# Access Compliance Report

## Public Rights-of-Way

### (Curb Ramps)

Intersection ID: 12267	Main Street: CENTRAL_AV	Cross Street: LOUISE_AV	Location: S
ADA ID: 6D641DA29C12	Ramp Type: Perp	Initial Pass/Fail: Fail	Overall Compliance: No
Severity Score: 8.75			
Codes/Mitigation Info/Possible Solution		Field Measurements/Component Compliance

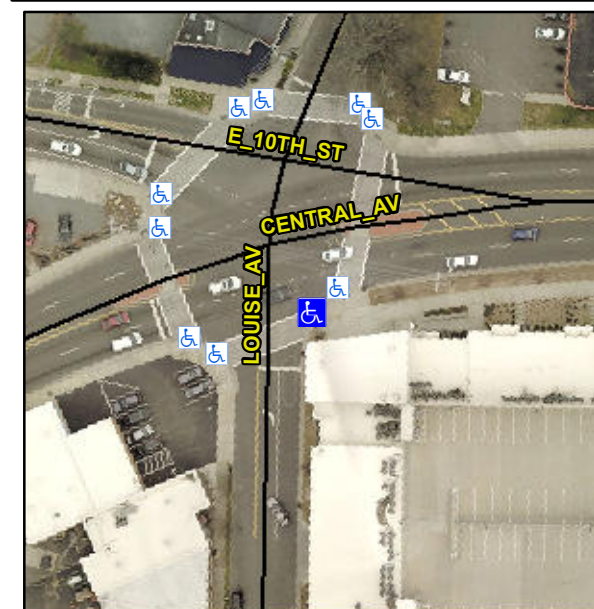
**Remove & Replace Entire Ramp.**

**Not Found, R304.5.1**
